BID ADDENDUM #2

Date: July 28, 2025

Project: RUHS Cardiac Catheterization Lab Suite & Hyperbaric Facility Expansion

Re: Bid Addendum #2

E5 DEMO @ (E) WINDOW FOR NEW ROOF ACCESS DOOR
SCALE: NTS

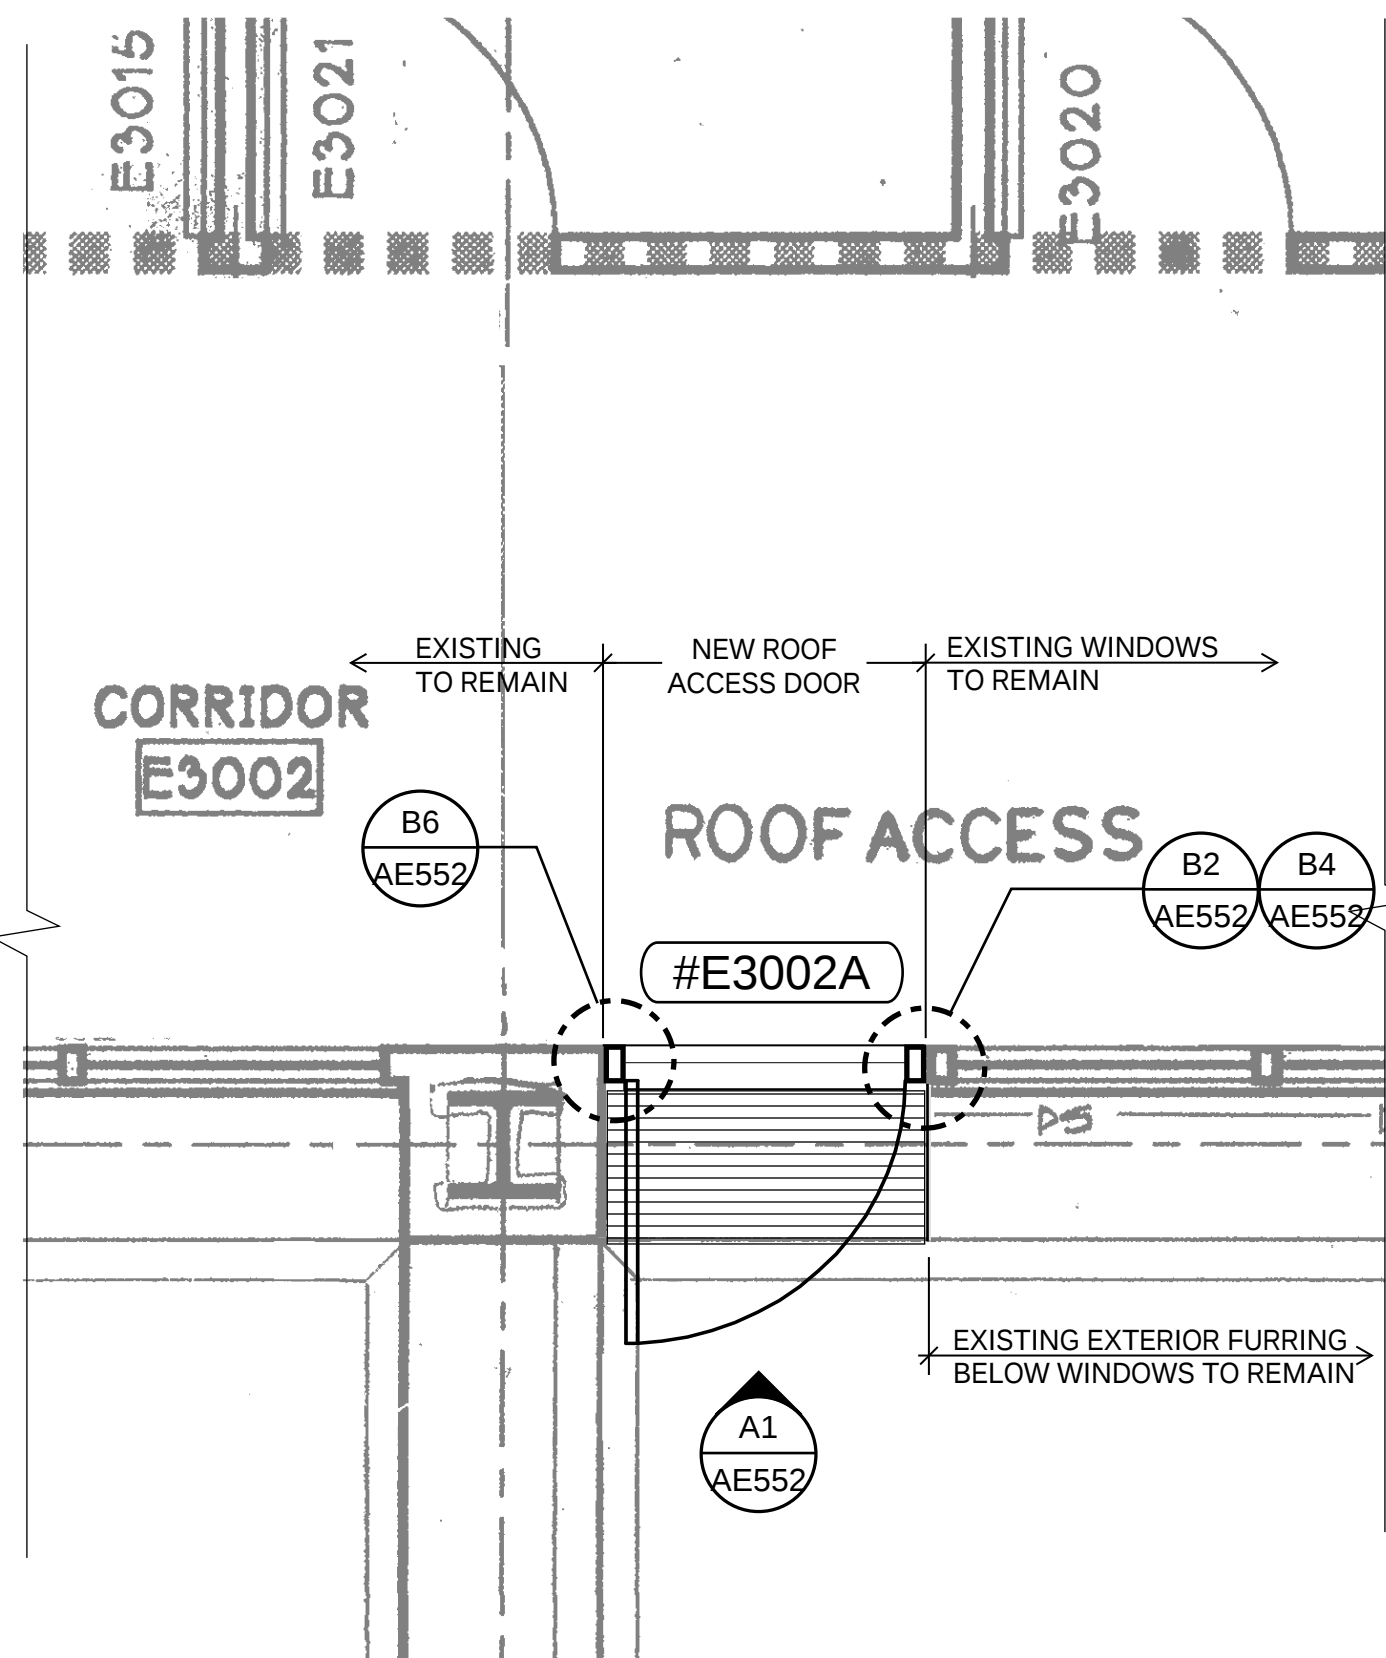
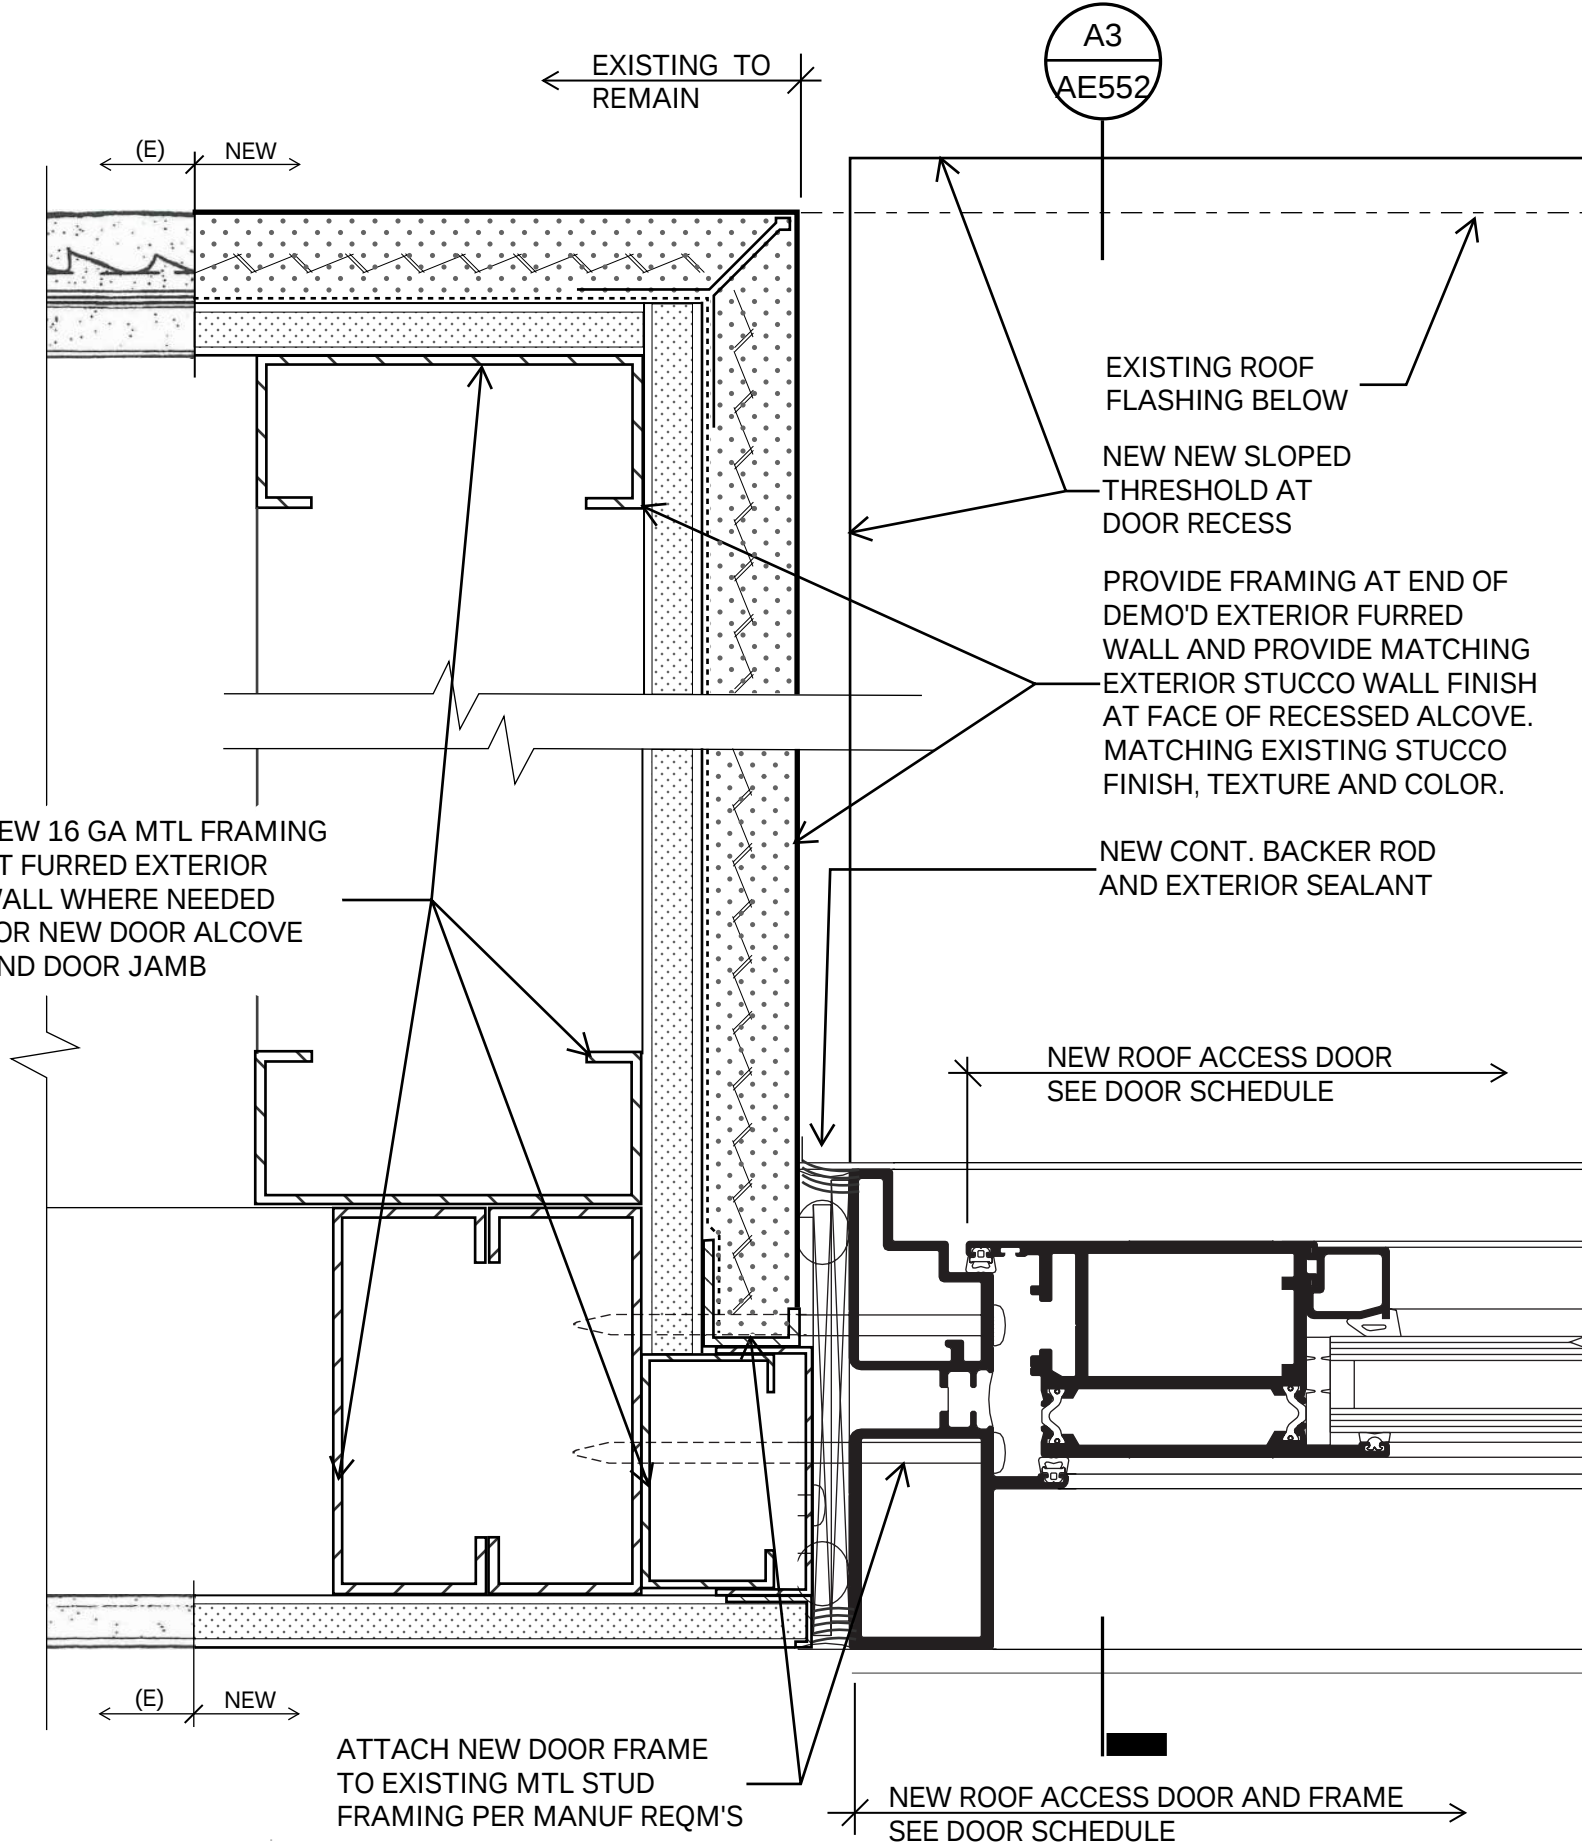
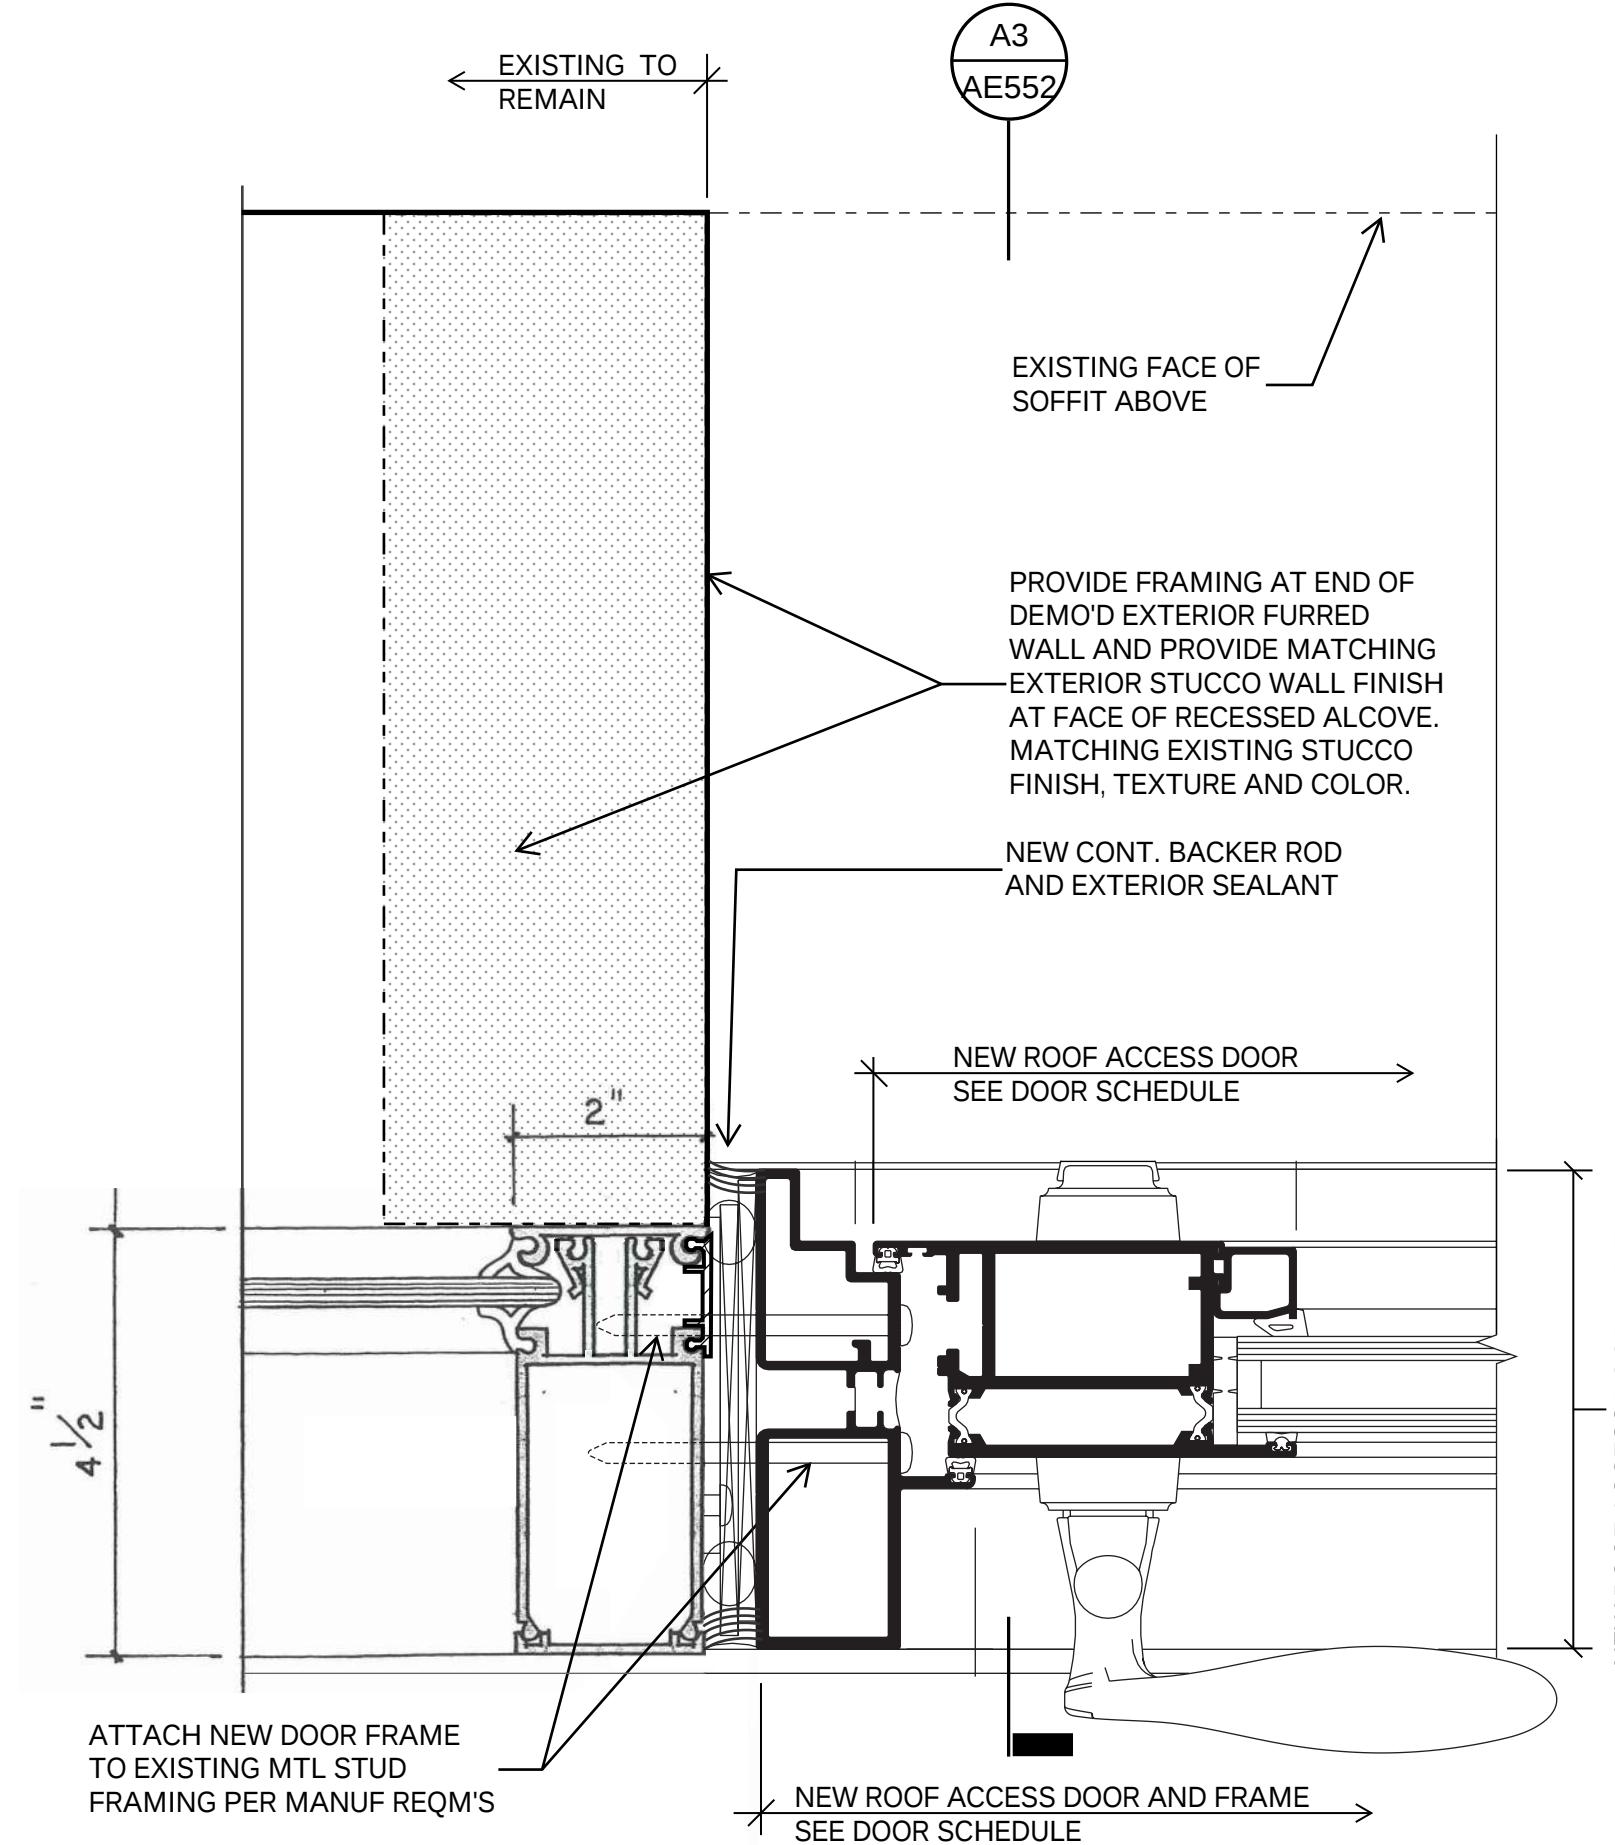
2. New demo plans and details describing the demo of an existing roof access hatch in the existing exterior storefront window and a portion of the exterior furred wall below the window.
3. New remodel plans and details describing the installation of a new roof access doorway within a single window bay of the existing exterior window system.
